Plan Commission

SUBJECT: Review and Recommendation on the Site Plan for 600 and 633
Heritage Rd for an Expansion at Belmark. Applicant: Robert E. Lee
and Associates

Item 3: Review and Recommendation on the Site Plan Application for 633 Heritage Rd for an Office Expansion to Belmark Plant #3 and Skywalk. Applicant: Robert E. Lee & Associates

RE: Application for Site Plan Review
Belmark, Inc
Plant 3 – Office Addition and Skywalk
Plant 1 – Office Renovation

LOWER LEVEL PLAN
 SCALE: 1/8" = 1'-0"

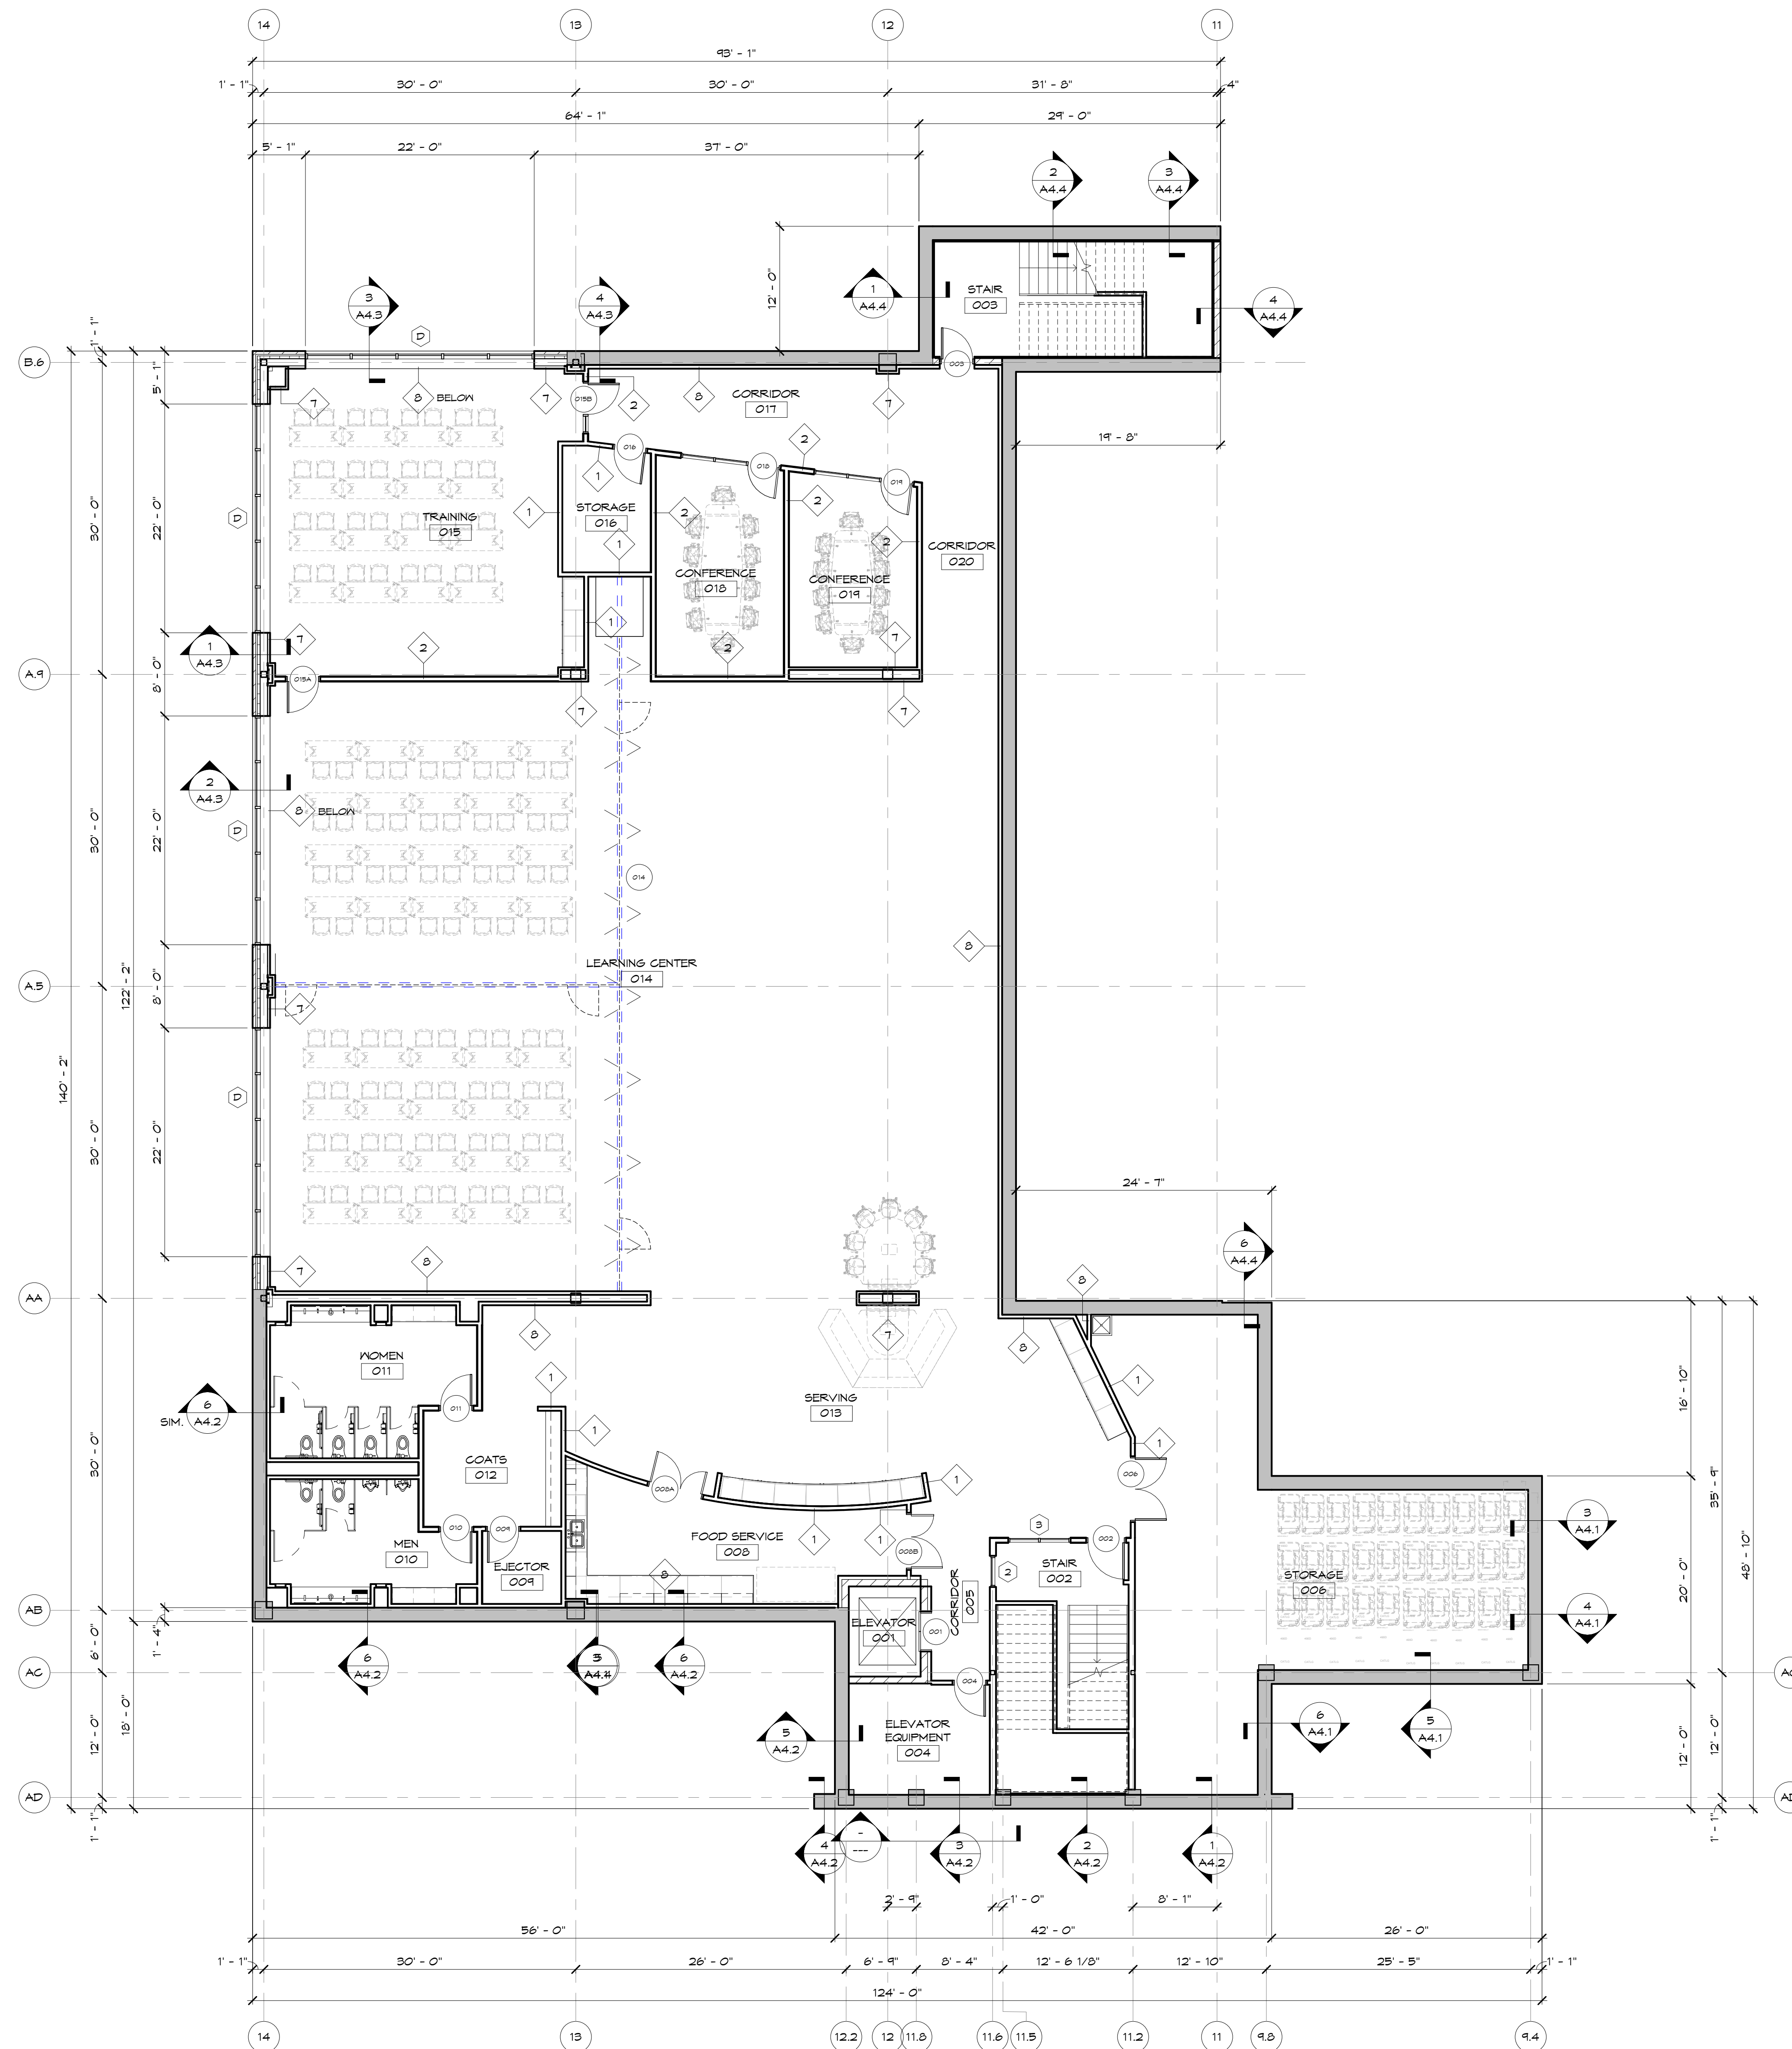
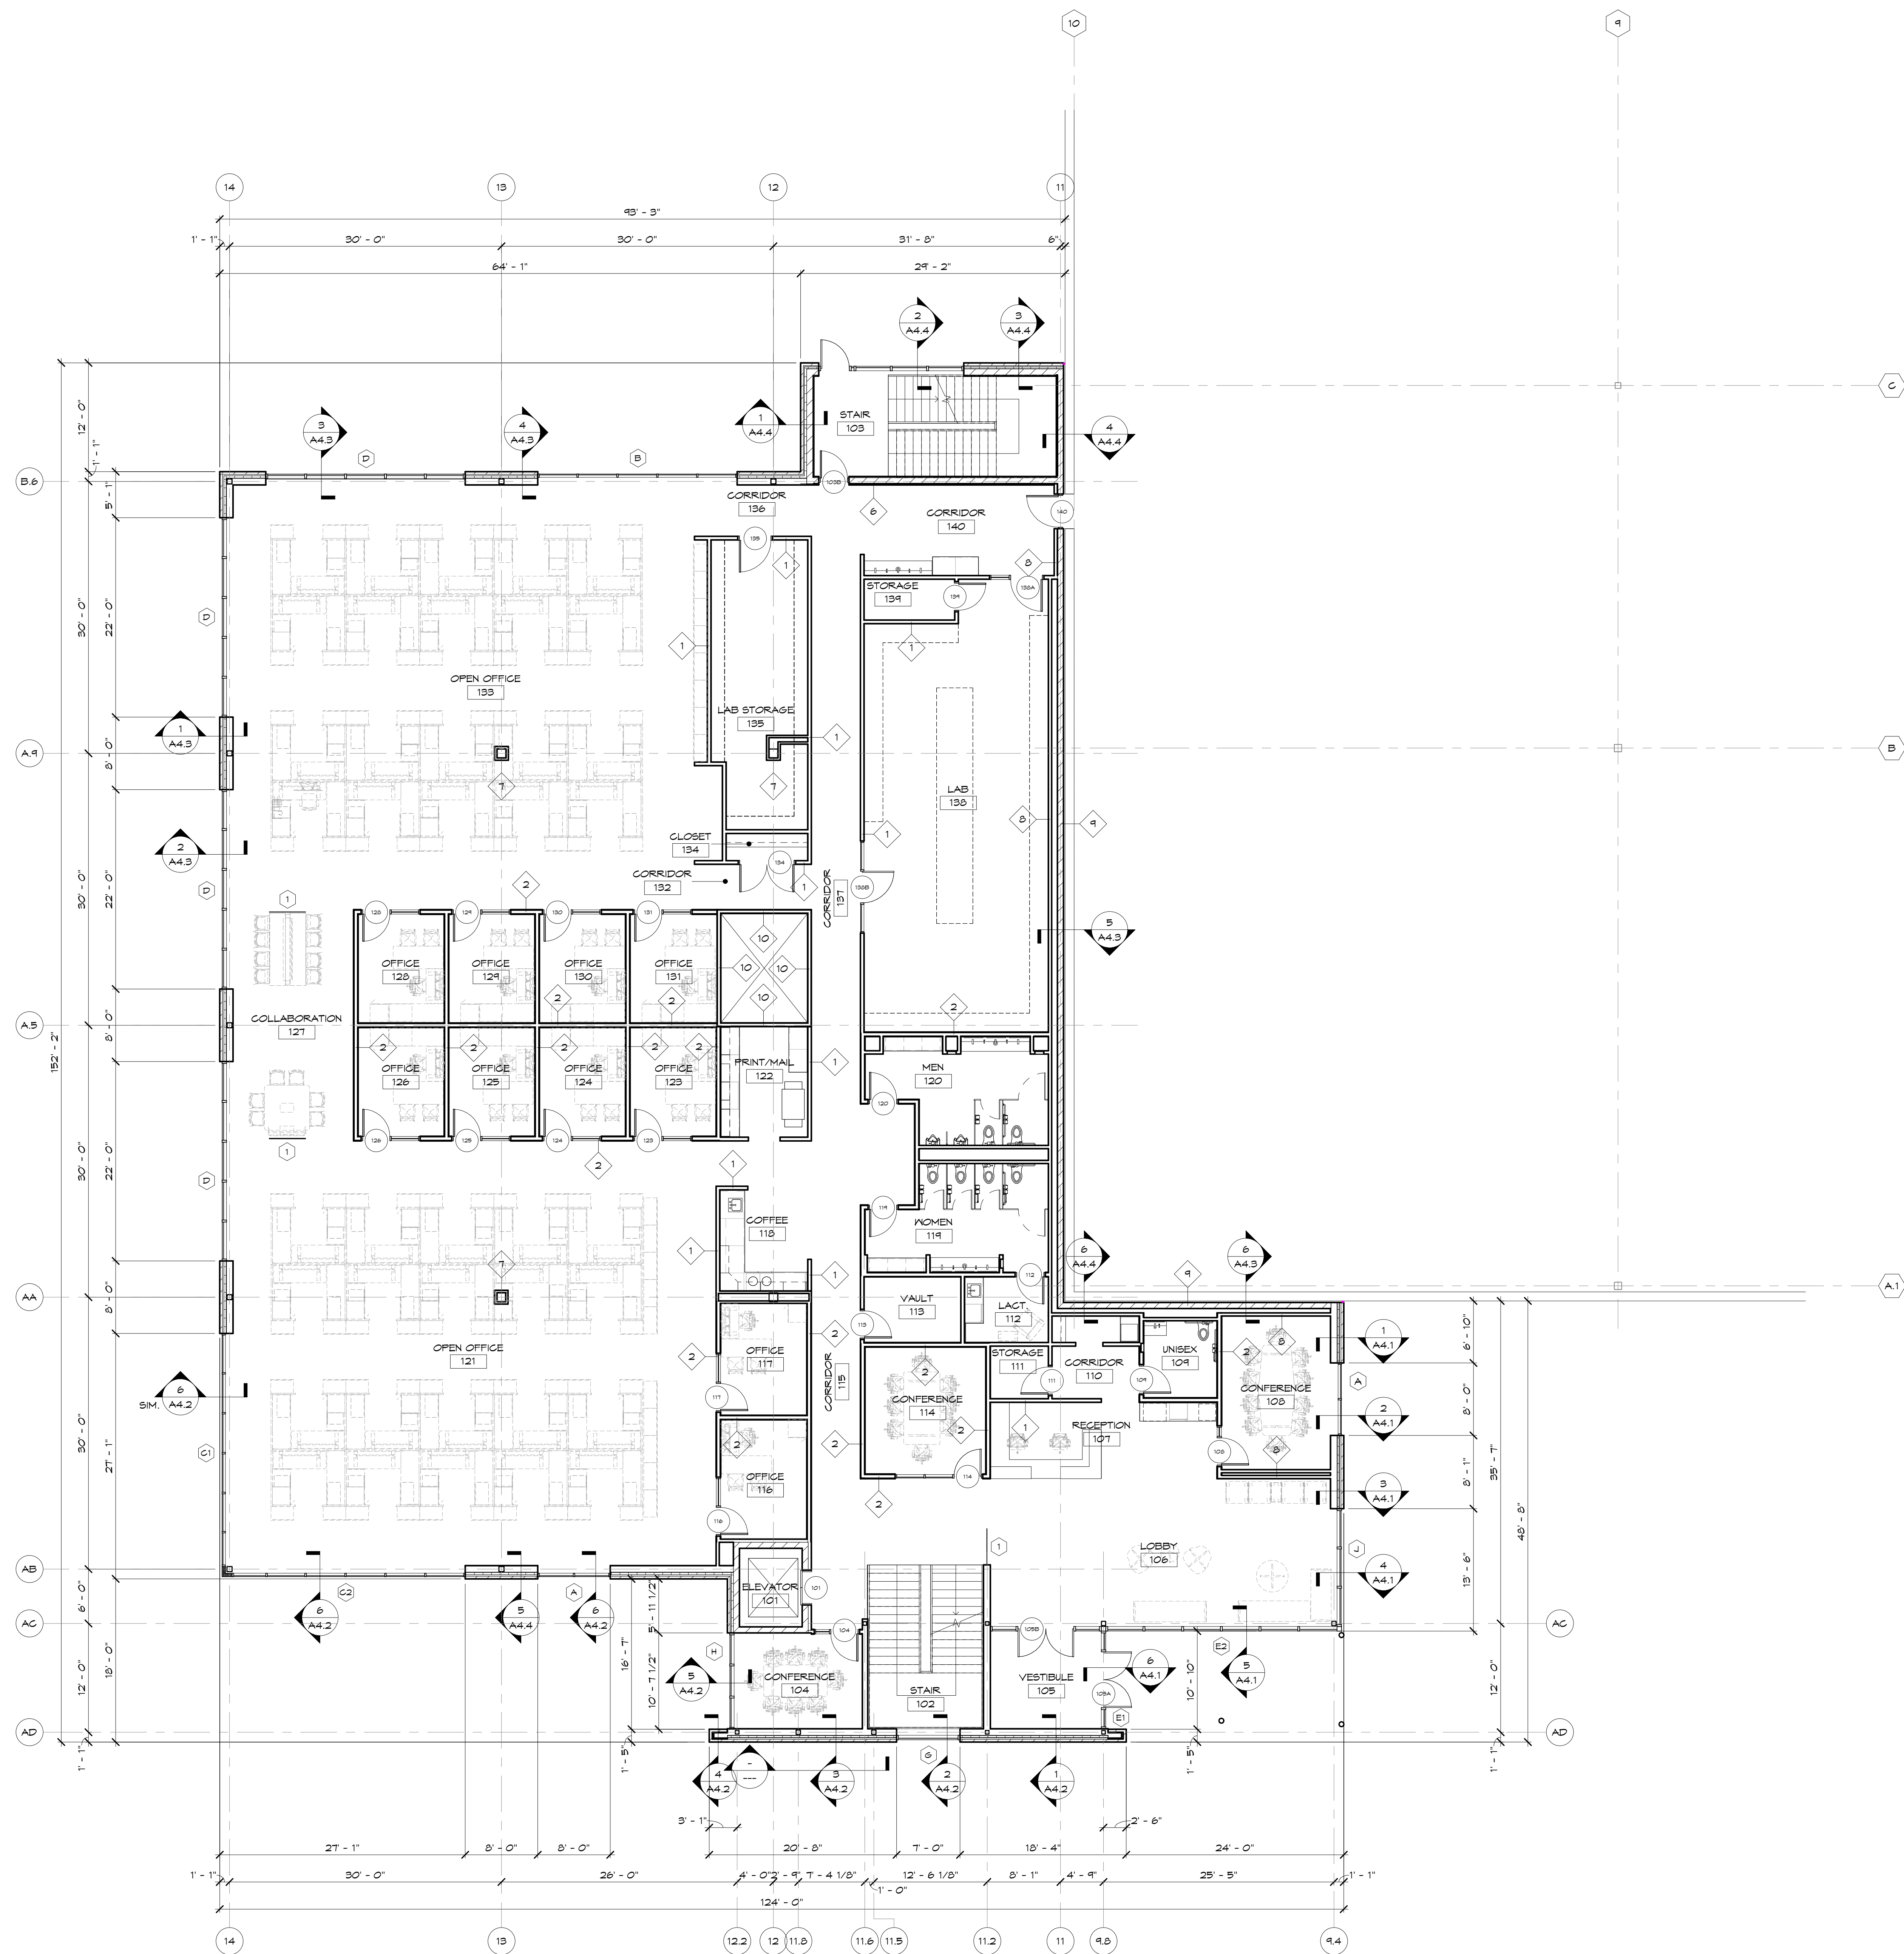
1. Page 12 shows diagram stating "Food Service" which appears to be more than a breakroom kitchen and area. Is this a cafeteria where meals prepared and offered for sale to employees? Please include equipment schedule with blueprints. I noticed an item labeled 8 but did not locate an equipment key to determine what number 8 references. Also, page 21 shows a breakroom and kitchen. Same question in terms of is this a breakroom only with a kitchen for employees to use for personal meals brought in to consume or is this a kitchen used for preparing and selling food to employees from a contracted food service company/Belmark hired food service employees? If meals prepared and sold to employees in either areas a health department restaurant license is needed.
